Comment # and Topic	Comment	Response																		
1 – Delineation	<p>Please provide a map showing all of the sample points taken for the wetlands delineation, including the paired sample points taken on either side of the delineated boundaries. Please include an explanation of the surface features used to draw the boundaries and any other technical work that was performed for this delineation.</p>	<p>Please see the enclosed <i>Updated Jurisdictional Delineation Report</i> for all observation locations within the coastal zone.</p> <p>The limits of the jurisdictional areas depicted in the enclosed <i>Updated Jurisdictional Delineation Report</i> are based upon the vegetation boundaries visible on aerial photography and confirmed in some locations using GPS based on the presence of hydrophytic plant communities. Soil pit data was not collected at this time as a result of restrictions on sampling on the Marine Corps property.</p>

Attachments

PROPOSED CONSTRUCTION AT SAN ONOFRE GATE

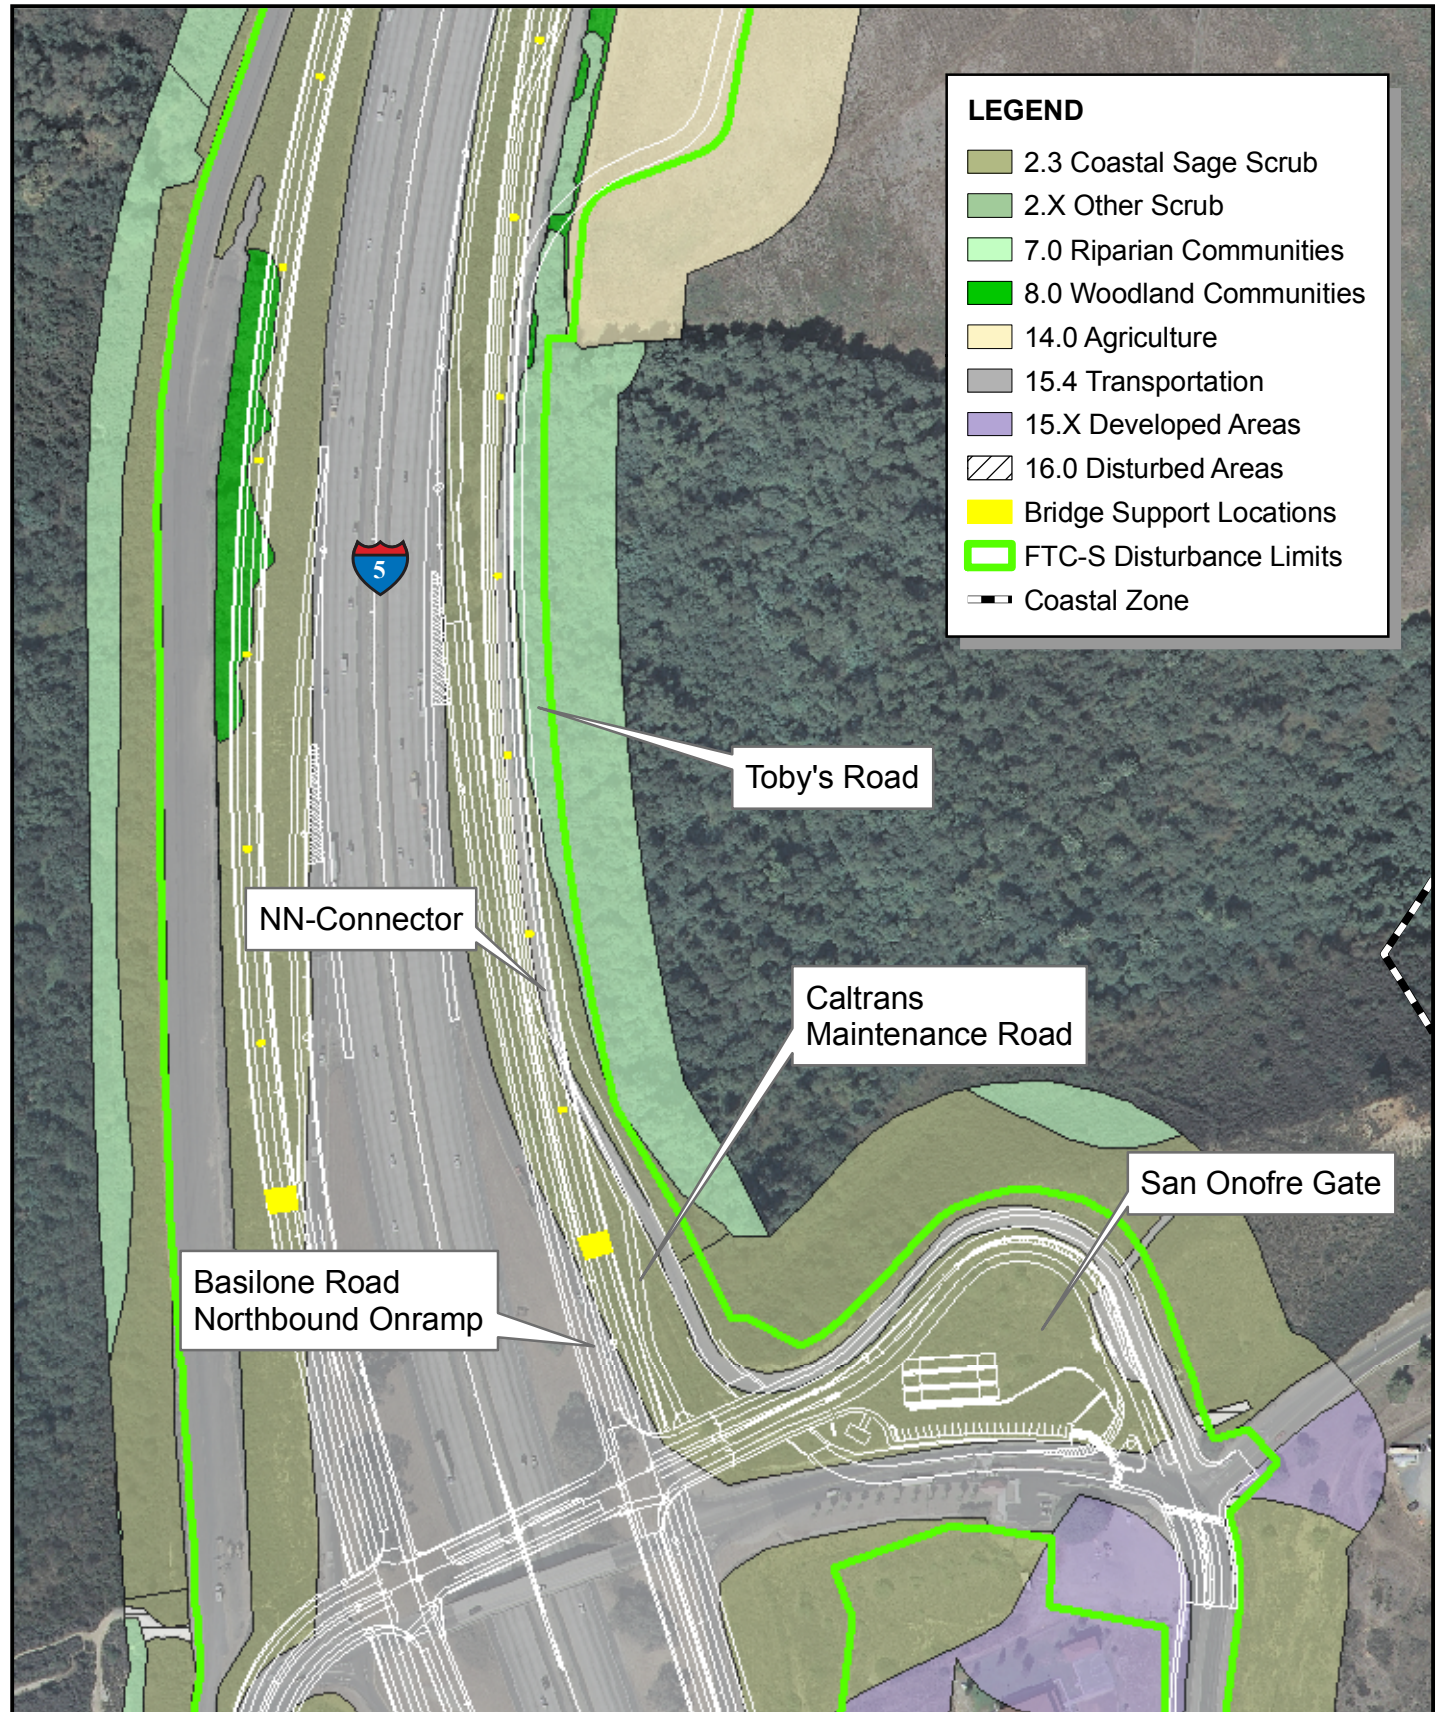
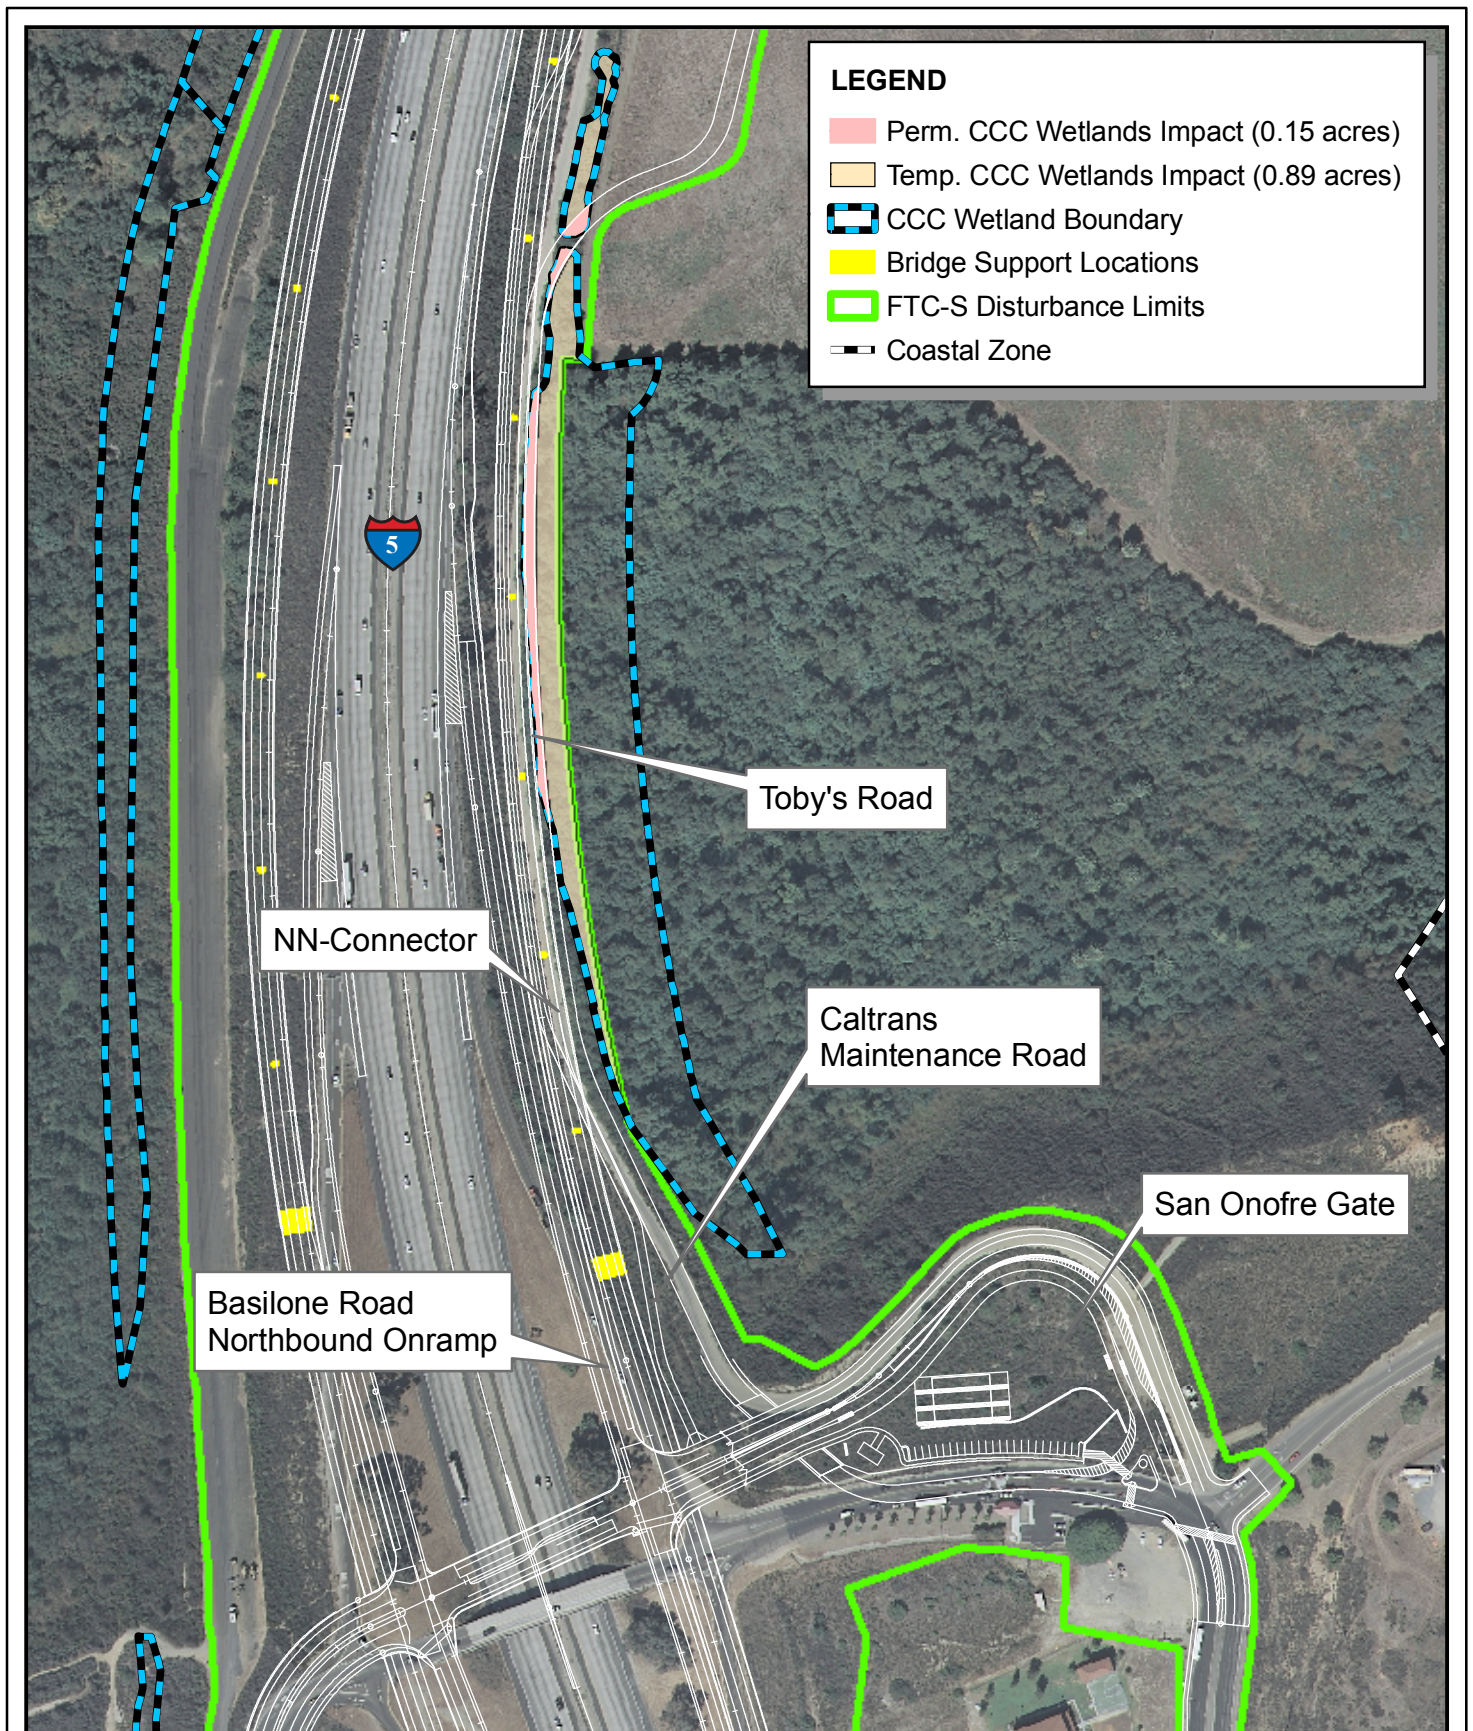
9 – San Onofre Gate	<p>San Mateo Marsh and San Onofre Gate- exactly what type of construction is proposed here (p.43)? There is no detailed description of the national security improvements in Section III.B as is stated. Please provide a map that details the proposed construction for the San Onofre Gate and shows the vegetation mapped* (including wetland</p>	<p>Please see <i>Attachment 6: Proposed Construction at San Onofre Gate</i> for maps of construction type and location, vegetation, and wetlands impacts.</p> <p>At the San Onofre Gate, the project includes expansion and reconstruction of the existing gate, and the reconstruction of the existing access road (Toby's Road) from Basilone Road to the military training area (former agricultural area) to align with the new Basilone Road configuration. These improvements will be constructed as requested by Camp Pendleton (at no cost to the U. S. government) to meet</p>

Comment # and Topic	Comment	Response
	<p>delineations) in and around the gate and San Mateo Marsh.</p> <p>* Please use a standardized vegetation classification system.</p>	<p>current homeland security guidelines. The new gate facility will include a new state-of-the-art enhanced security facility, six sentry houses, a 510 square foot gatehouse, dual guard stations, three truck inspection areas with canopy, a watchtower, a visitor processing office, upgraded control gates and perimeter fencing and a parking area. The paved area (including the access road) will be 3.5 acres and will include drainage facilities, lighting (pole-mounted lighting and roadway lighting), signing and utilities.</p> <p>The realigned Toby’s Road will pass under the realigned Basilone Road via an arch culvert. Toby’s Road will provide access to the military training area to the north of I-5 (former agricultural area) and will also be extended to provide a new access under the southerly abutment of the San Mateo Creek. This road will provide access for Camp Pendleton personnel between one side of I-5 to the other in this area, where no access currently exists.</p> <p>A Caltrans maintenance road will be provided from the Basilone interchange to a sand filter basin (SFB) located south of San Mateo Creek.</p>
